APPENDIX C – RMA RESPONSE – ENGINEERING ISSUES:

Project Name: Subdivision at 802 McDougall Street
Project No: 9829

Please find below our responses to Engineering Issues 3.2 and 4.1 as raised by Council in their letter dated 27 March 2018 and clarified at the meeting on 7 November 2018, for inclusion in your overall response to Council. The issues have been numbered as per Council's letter for ease of reference.

PLAN – BOUNDARY STREET
Scale 1:1000 (A1)

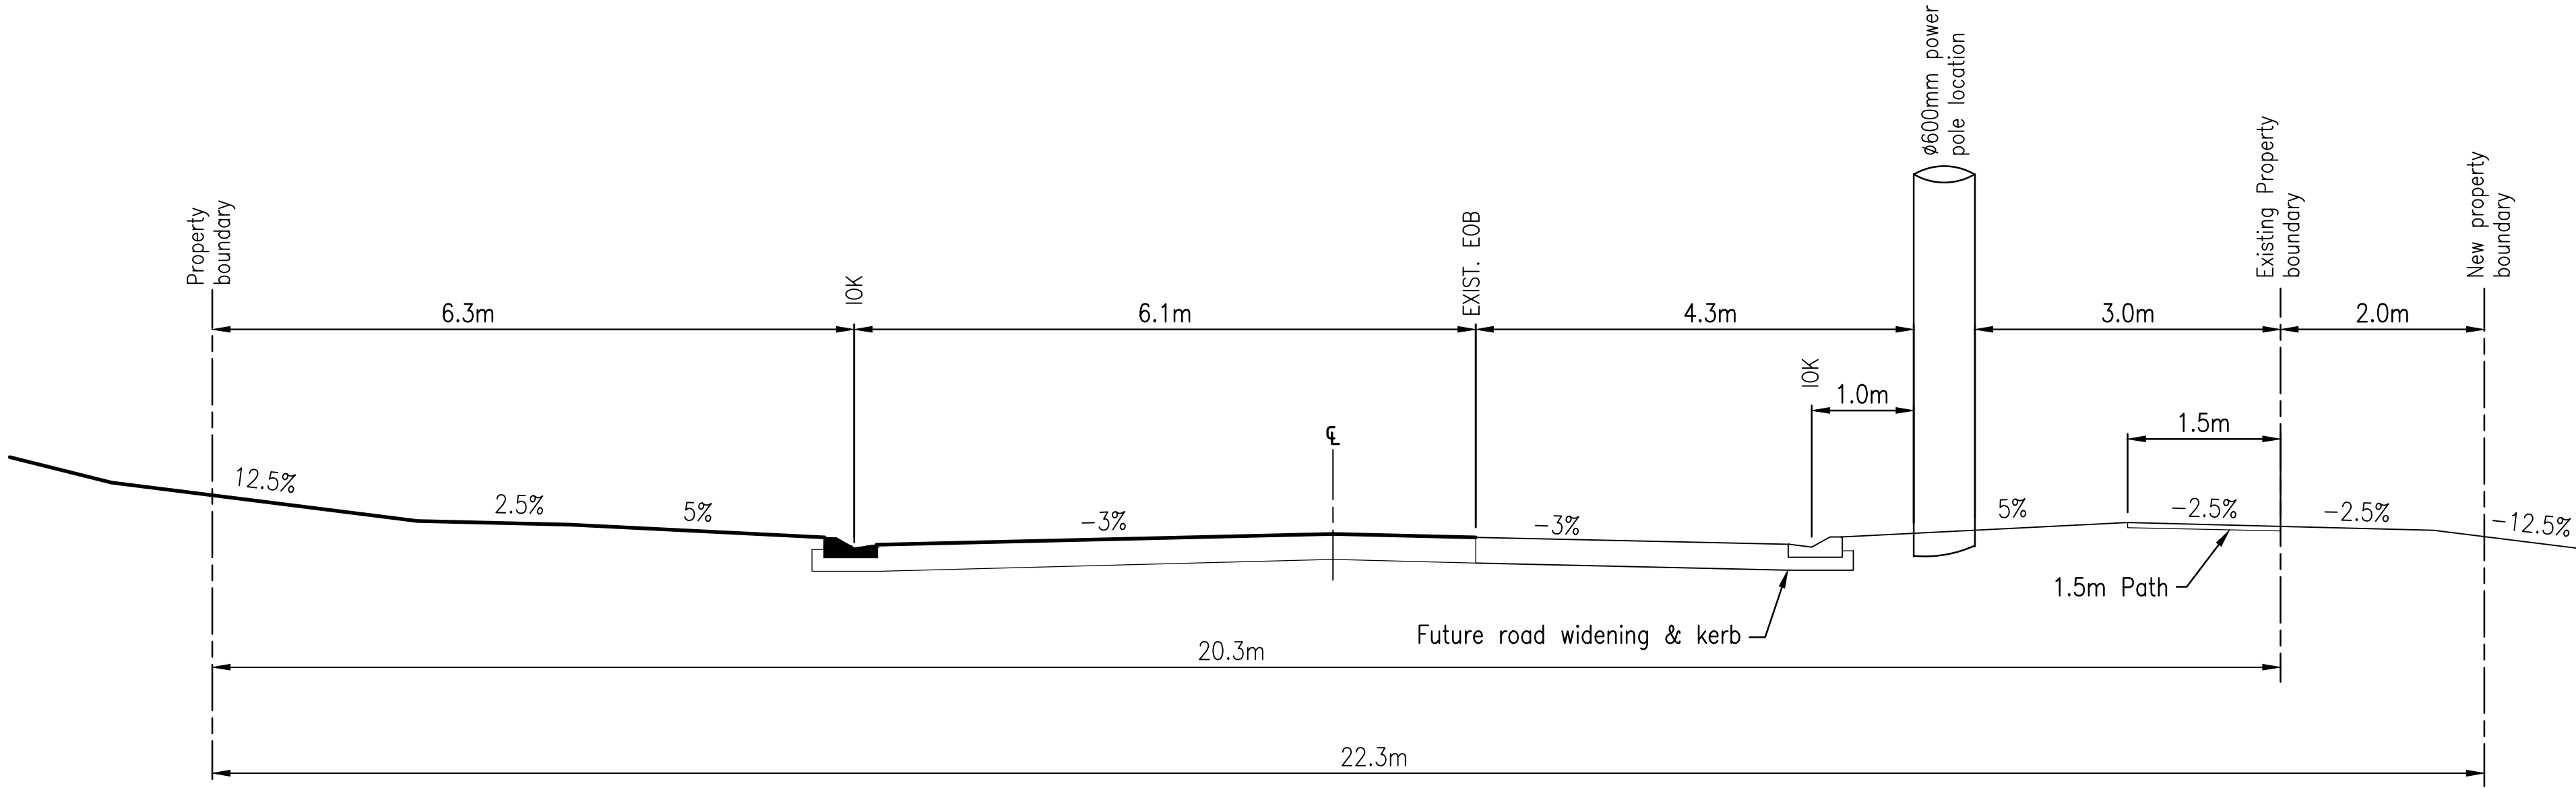
3.2. The applicant is requested to amend the proposed development plans to show a 4.5m widening in lieu of the proposed 2m widening to the Boundary Street frontage;

Drawing CSK117 has been prepared showing the location of the significant power poles along the frontage. Figure 1 below shows the existing pole located near the northern end of the Stage 1 Boundary Street frontage. Figure 2 below shows the existing power pole and an existing transformer located near the southern end of the Stage 1 Boundary Street frontage.

Assuming Boundary Street is widened in the future, the location of the eastern kerb alignment would need to be a minimum 1.0m to the west of the existing power poles. Any additional widening of the pavement (and road reserve) would need to occur on the western side of Boundary Street due to the location of the significant power poles.

Based on a future eastern kerb alignment at 1.0m to the west of the power poles and a 2.0m road dedication as part of Stage 1, a verge width of at least 6.6m will result along the Stage 1 Boundary Street frontage. This width is more than adequate to accommodate the existing electrical infrastructure and proposed footpath.

We believe that Council's latest request to provide a further 2.5m widening to the road reserve (4.5m in total) is not necessary to achieve a suitable verge profile and contain the required infrastructure. The additional reserve width would only result in the loss of residential land for no real benefit. The applicant remains firm on their position that only a 2.0m road reserve dedication width is reasonable and relevant to the development proposal.

PRELIMINARY SEWER LAYOUT – STAGE 1 & 2
Scale 1:500 (A1)

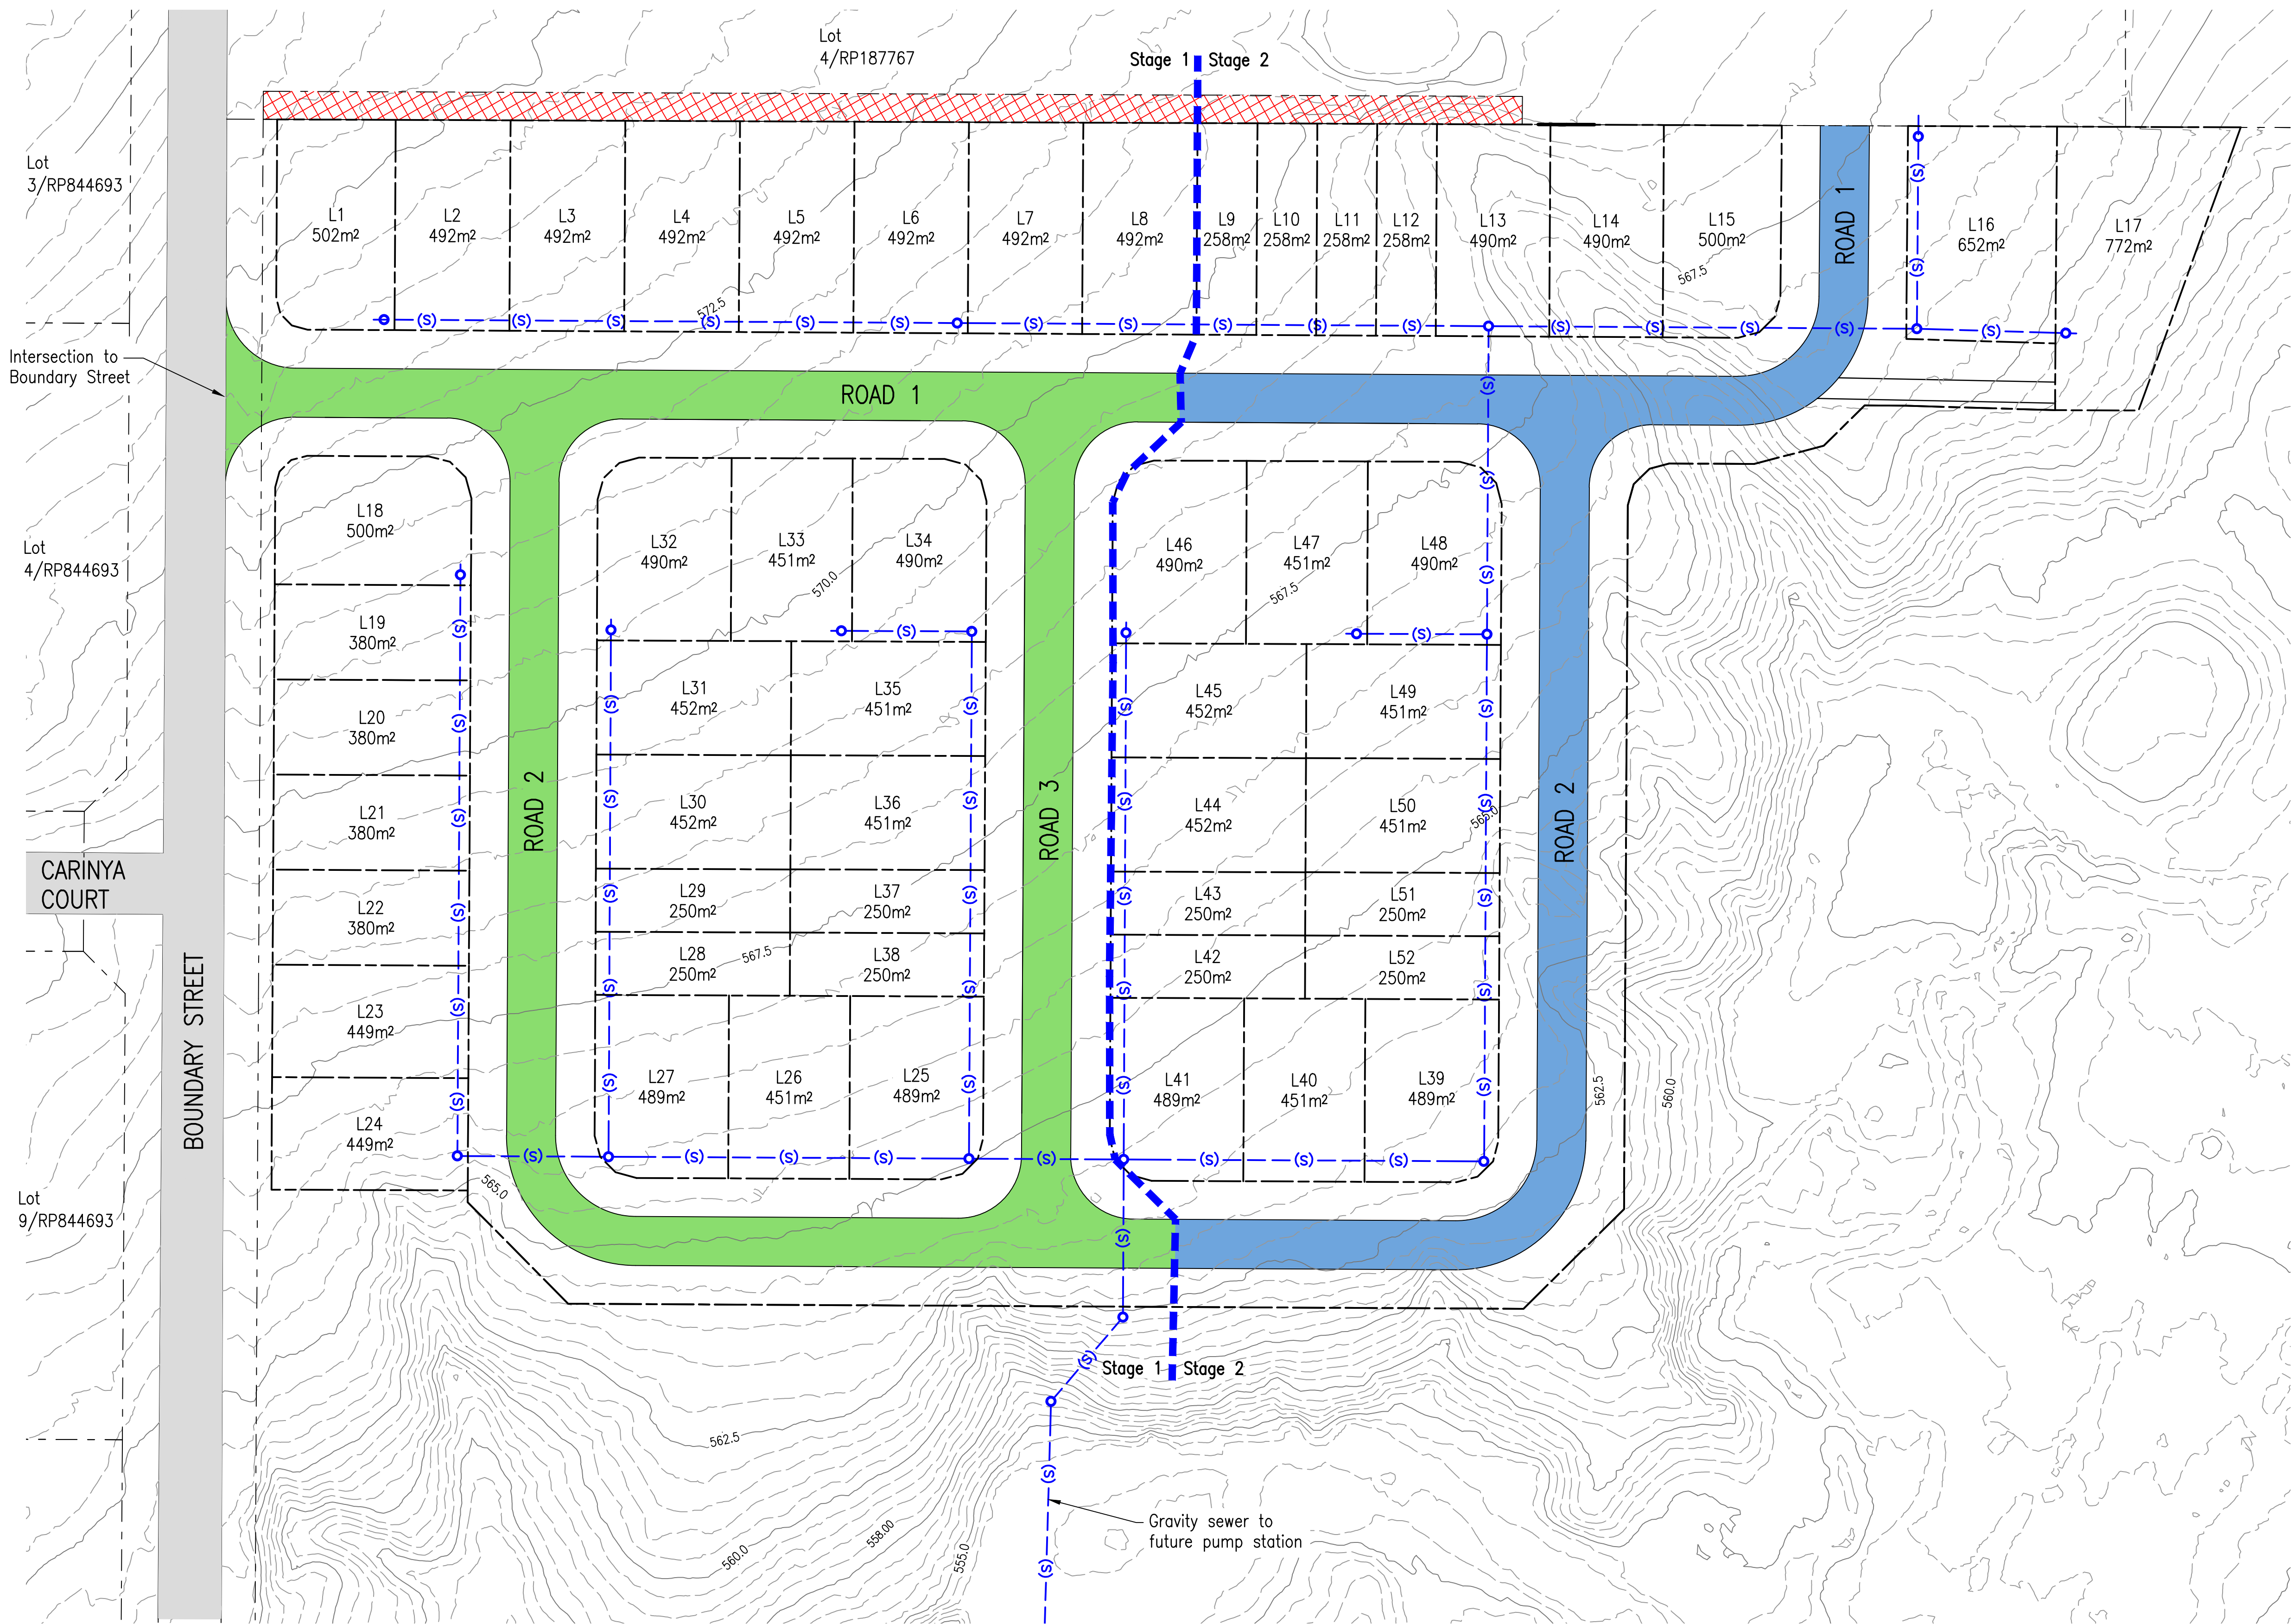
The proposed service easements on Lots 51, 52, 37 and 38, are not continuous to a street frontage. One of the purposes of the easements is to facilitate access to the proposed sewer infrastructure.

4.1. The applicant is requested to demonstrate how the proposed rear easements will functionally provide access through neighbouring property.

Refer attached drawing CSK106. The sewerage layout has been reconfigured to relocate the sewer from the rear of the small lots, removing the requirement for any easements within the allotments.

Council can still apply a standard condition to the approval requiring easements for sewers in small lots in accordance with Planning Scheme Policy No. 3, if the situation arises at operational works phase that a sewer in the rear or side of a small lot is required.
